Ref: 0417r02v02

**RE: 227 BUNGARRIBEE ROAD, BLACKTOWN (DA-21-00559)
KRISHATHI PTY LIMITED -V- BLACKTOWN CITY COUNCIL (LEC CASE NO. 2021 / 146822)
LETTER OF RESPONSE TO TRAFFIC CONTENTIONS**

We refer to recent correspondence concerning the abovementioned Court proceedings and the Statement of Facts and Contentions (SOFC) issued by Blacktown City Council (Council) dated 14/07/2021, relating to the deemed refusal of Development Application, DA-21-00559.

Attachment 2

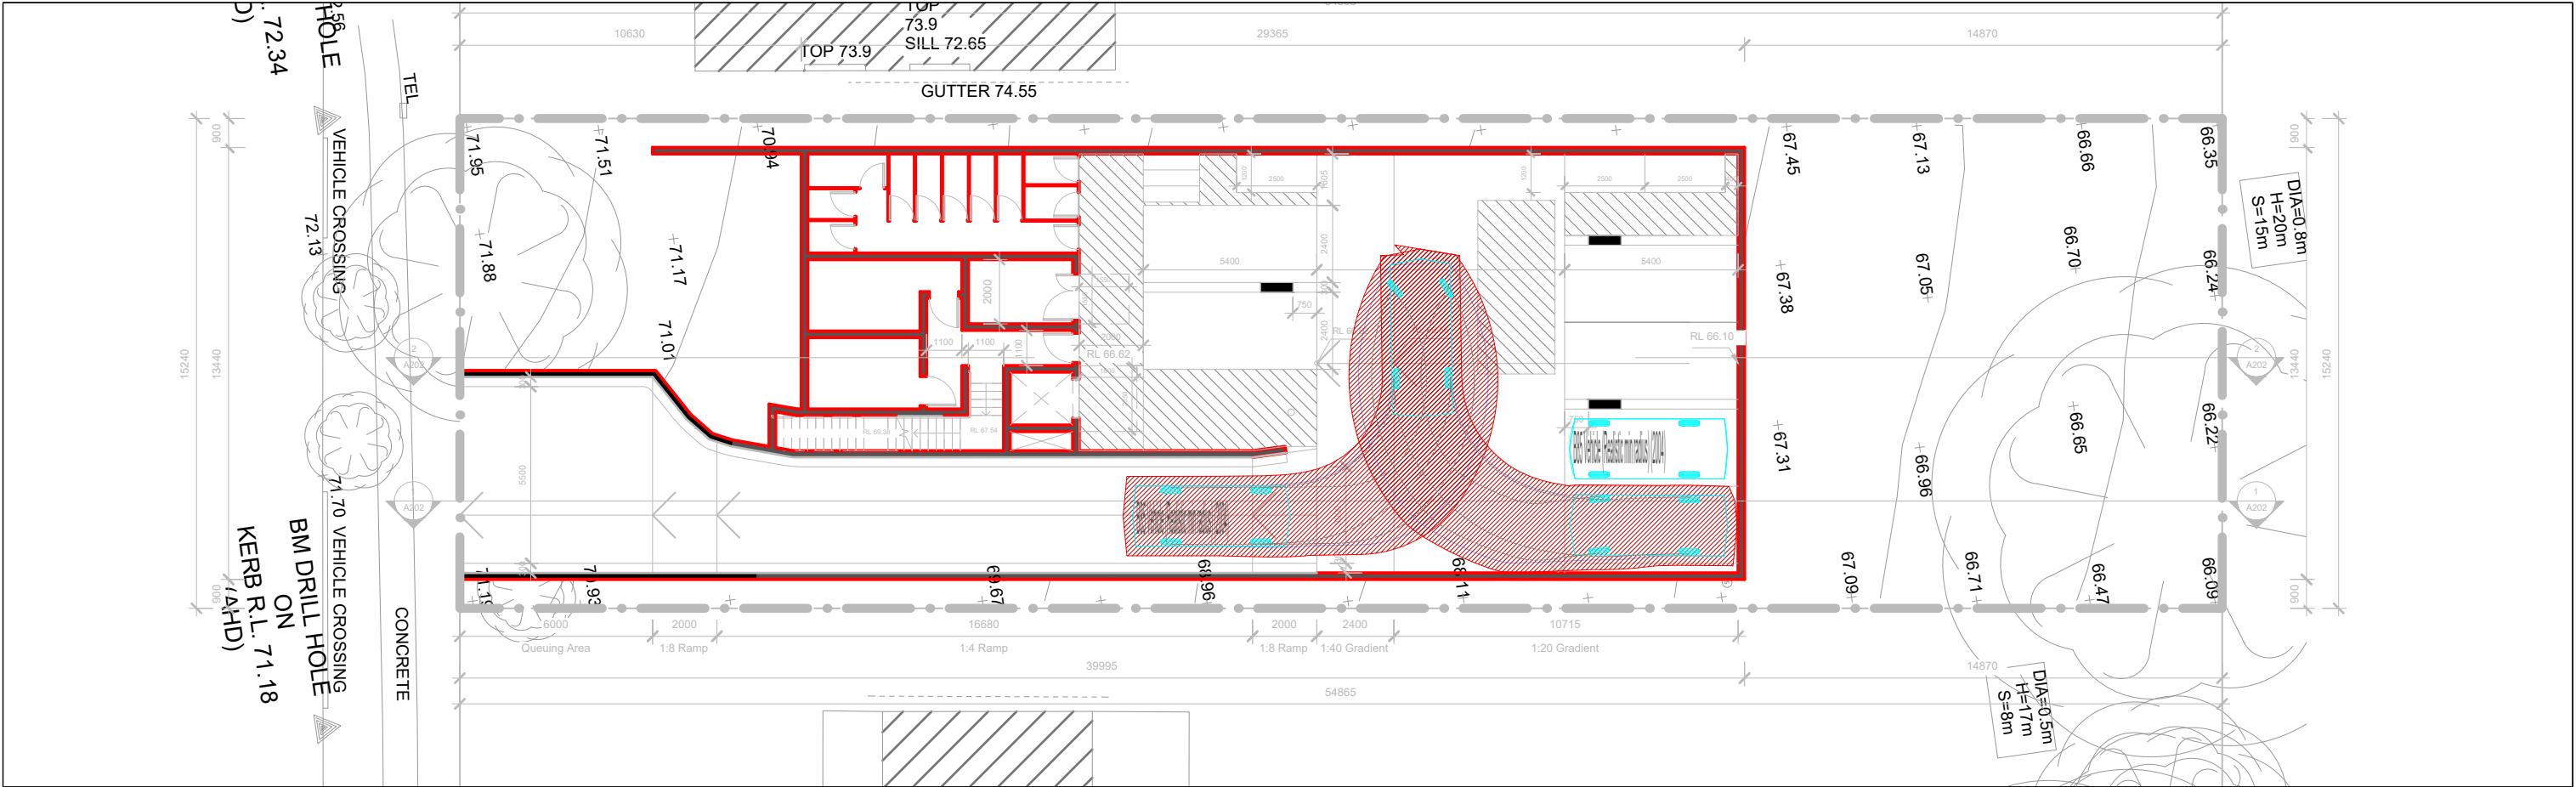
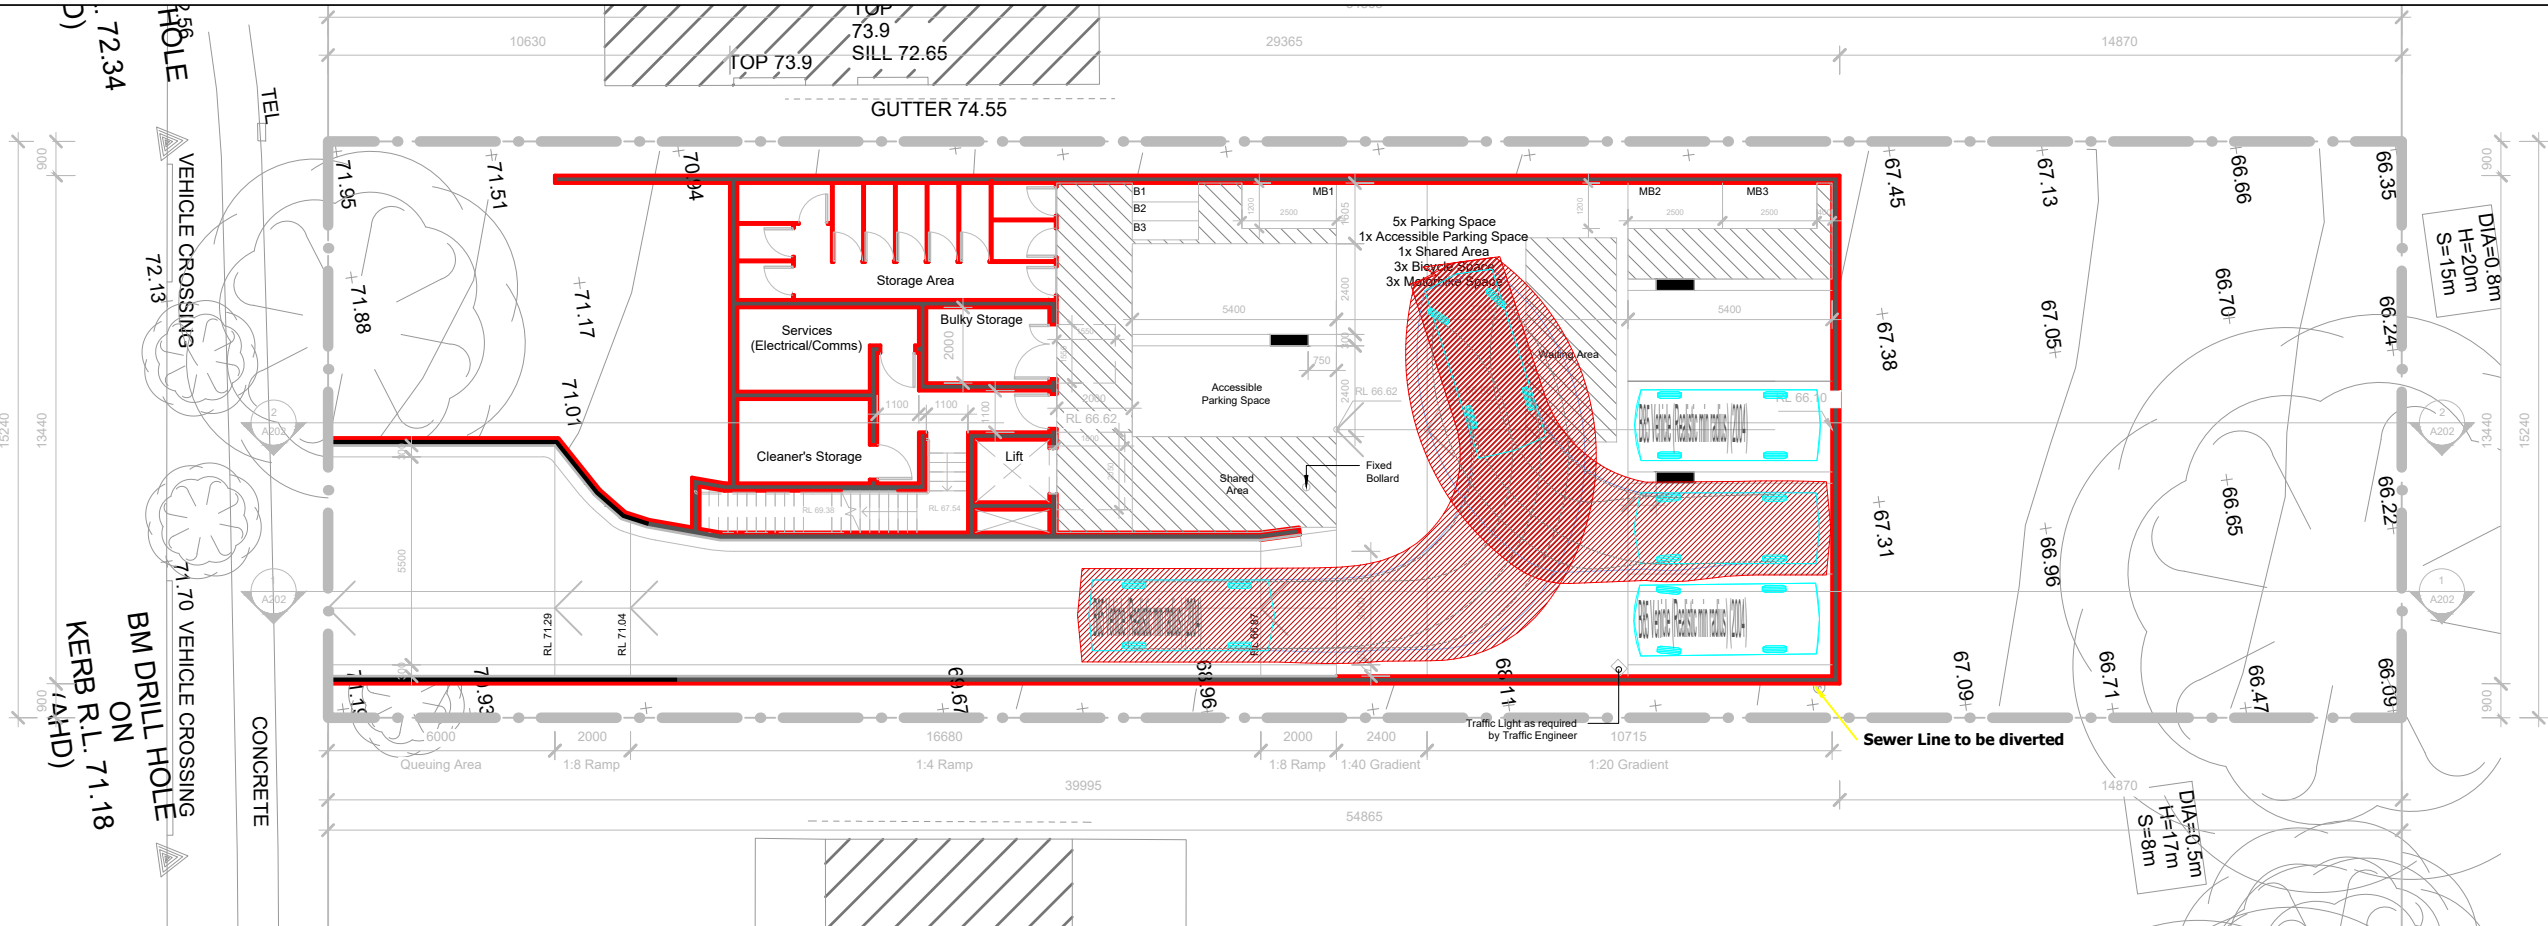
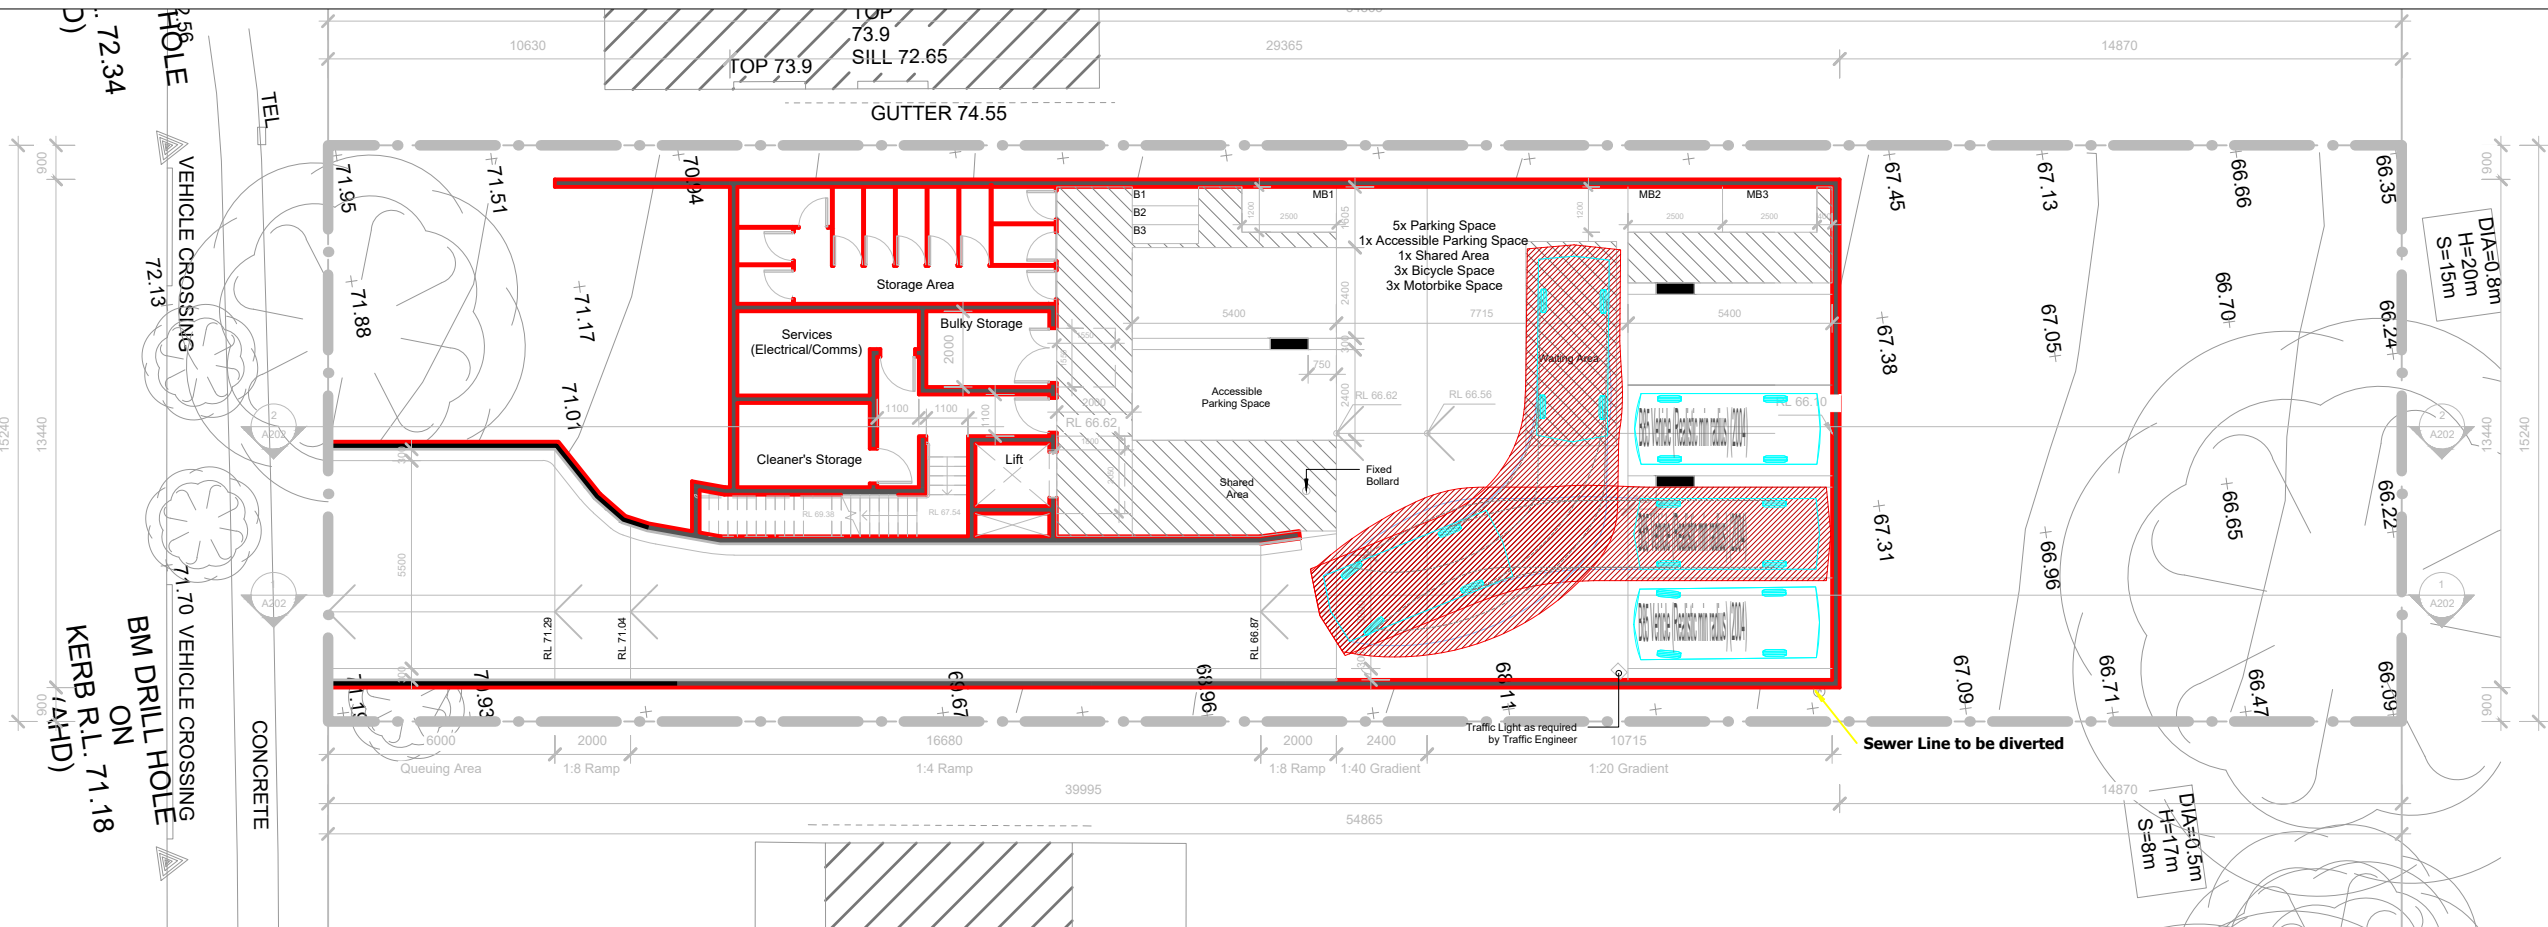
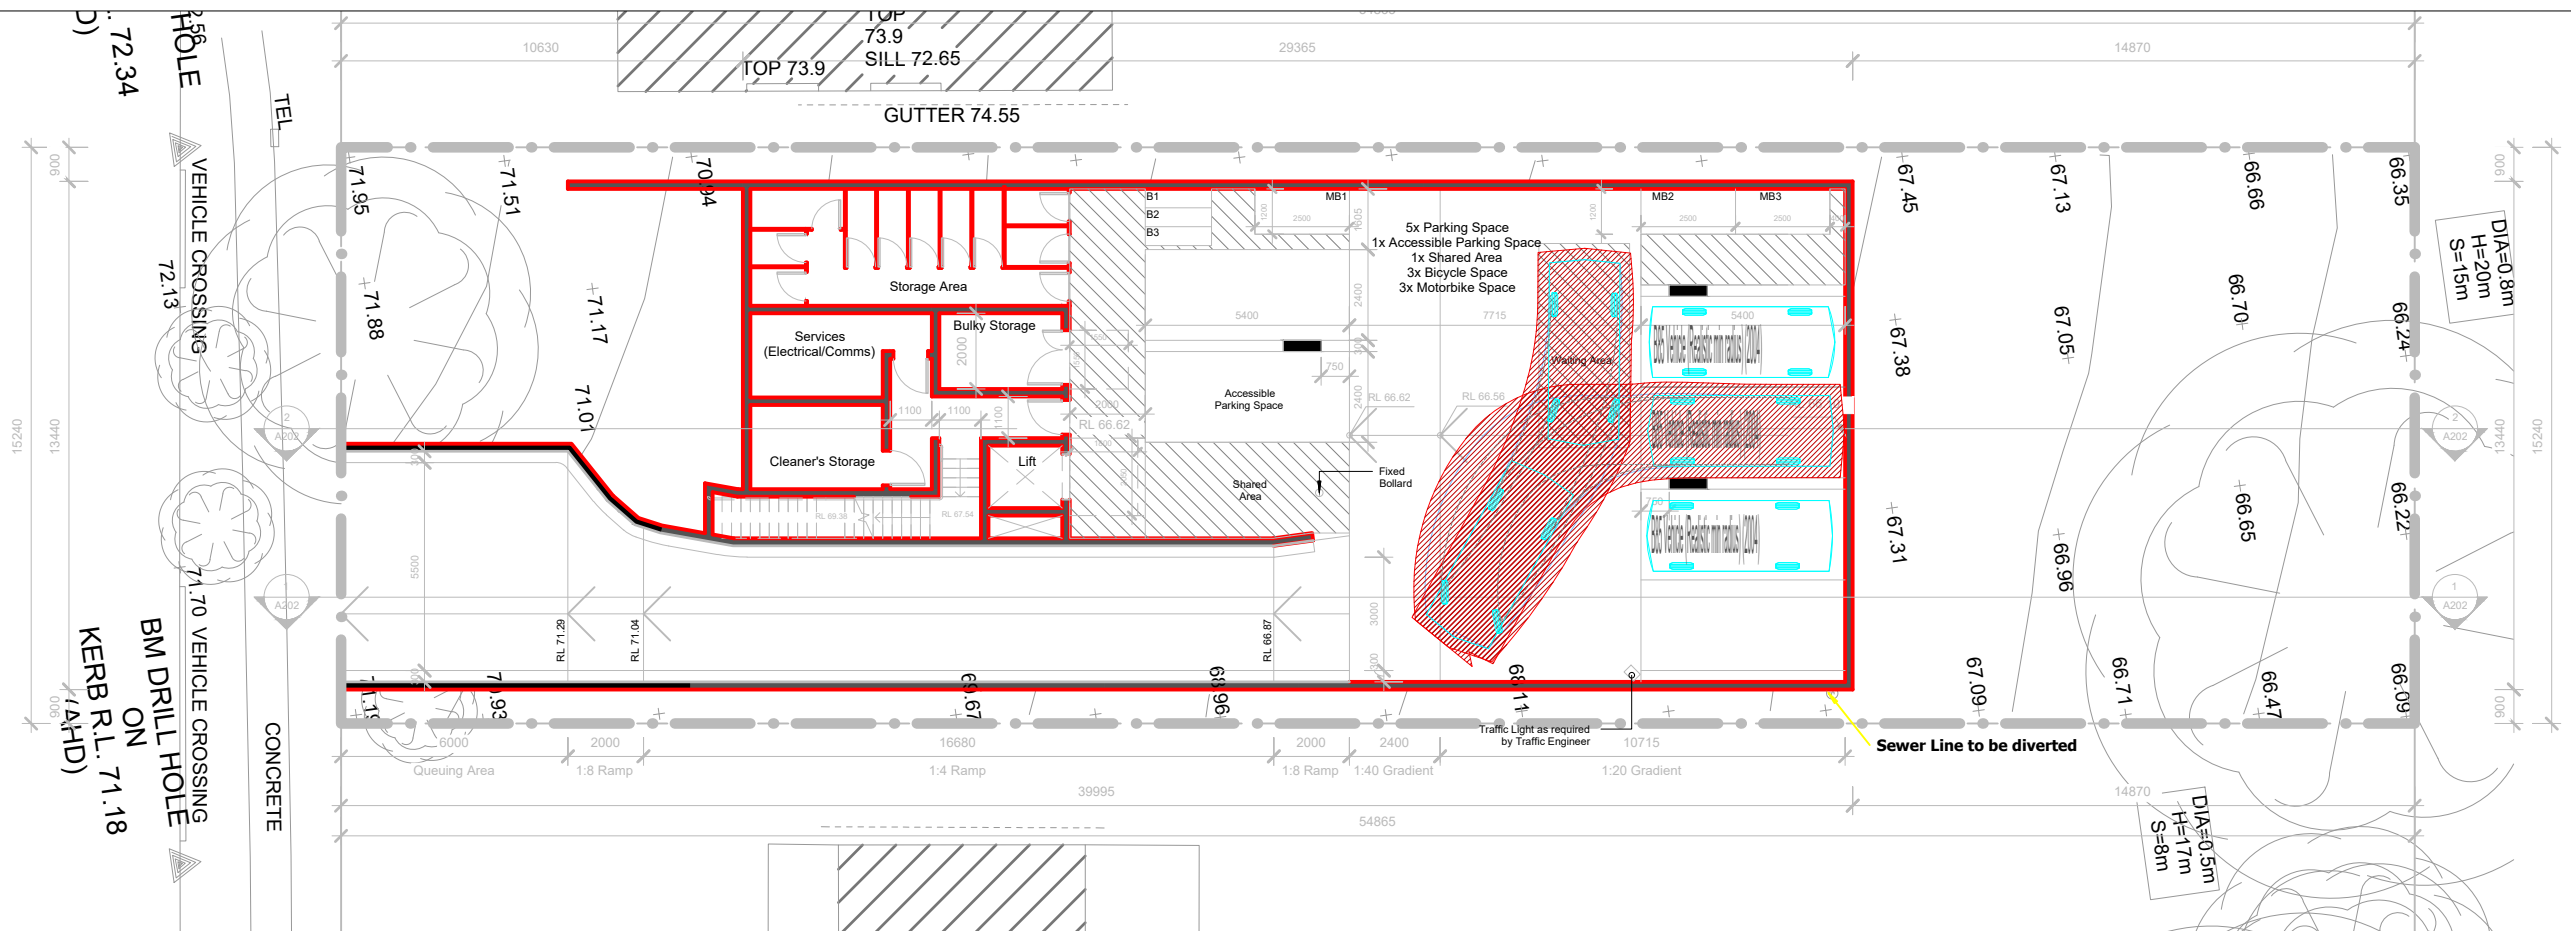
b) Insufficient turning circles have been provided in accordance with Section 2.5.2 of AS2890.1 for passing at the site driveway and within the basement. Turning paths are to be provided for the B99 design vehicle turning left into the site driveway from the public road and passing a B85 design vehicle exiting the site in addition to swept paths for the B99 design vehicle within areas designed for use by one vehicle at a time.

d) Turning circles in the basement are not practical or workable for cars. The results show the required 0.3m vehicle clearance overlapping with high obstructions (walls, columns, motorcycle spaces, kerbs and car parking spaces) which is contrary to the requirements of AS2890.1. It appears 'turn on spot' has been used for swept paths (basement and along the driveway) which is a design flaw not representing realistic vehicle manoeuvres. The dwg files for the swept paths are to be provided.

Updated swept path analysis has been undertaken of the vehicle access with the results provided as **Attachment 2**. The results demonstrate satisfactory turn movements for a:

- B99 Design Vehicle turning left-in and left-out of the access driveway from the public road and passing a B85 Design Vehicle.
- B99 Design Vehicle entering the basement car park and passing a B85 Design Vehicle situated within the waiting bay.
- B99 Design Vehicle exiting the basement car park.
- B85 Design Vehicle entering / exiting all car spaces.

The results demonstrate satisfactory operation of the car park and compliance with Appendix B of AS 2890.1.

As per our respond to Contention 6(b), updated swept path analysis has been undertaken of the basement, including for entry / exit to all car spaces with the results provided in **Attachment 2**.

The 'turn from stop' function has only been used where a vehicle has changed from a forward-movement to a reverse-movement or from a reverse-movement to a forward-movement as is standard practice in the traffic engineering profession. The updated swept path results also show that 0.3m clearances are now clear of all vehicle obstructions including walls, columns, motorcycle spaces, kerbs and car parking spaces.
